SUNDRY NOTICES AND REPORTS ON WELLS
Do not use this form for proposals to drill or to re-enter an abandoned well. Use Form 3160-3 (APD) for such proposals.

| 2. Name of Operator Vanguard Operating, LLC | | 8. Well Name and No. China Federal #1 |

**China Federal 1
30-005-60863
Vanguard Operating, LLC
October 16, 2018
Conditions of Approval**

AFTER P&A

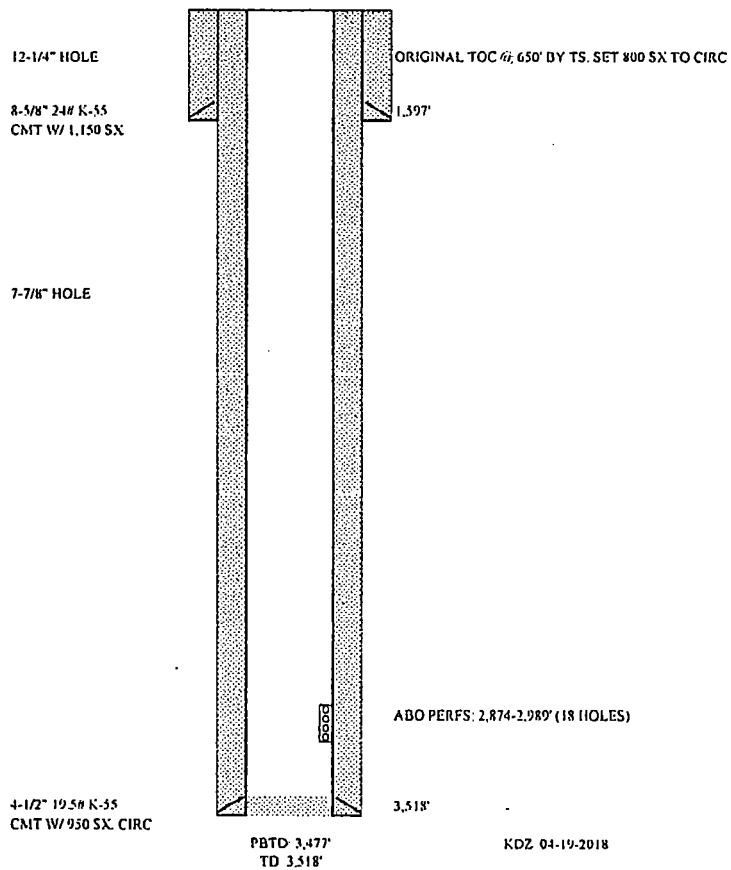
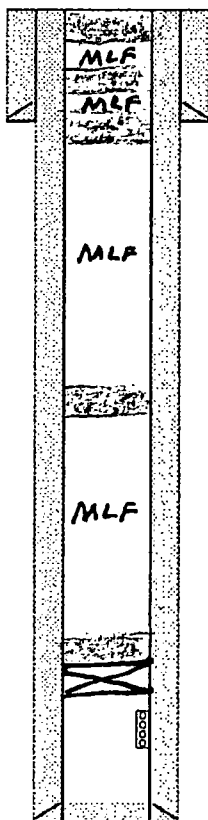
- 1. Operator shall place CIBP 2,824' (50'-100' above top most perf) and place 25 sx of Class C cement on top to seal the Abo Formation. WOC and TAG.**
- 2. Operator shall place a Class C cement plug from 2,200'-2,100' as proposed. WOC and TAG.**
- 3. Operator shall place a Class C cement plug from 1,650'-1,500' as proposed to seal the 8-5/8" shoe. WOC and TAG.**
- 4. Operator shall place a Class C cement plug from 800'-550' as proposed to seal the Glorietta Formation. WOC and TAG.**
- 5. Operator shall perf and squeeze at 100'. Operator shall place a Class C cement plug from 100' to surface as proposed.**
- 6. See Attached for general plugging stipulations.**
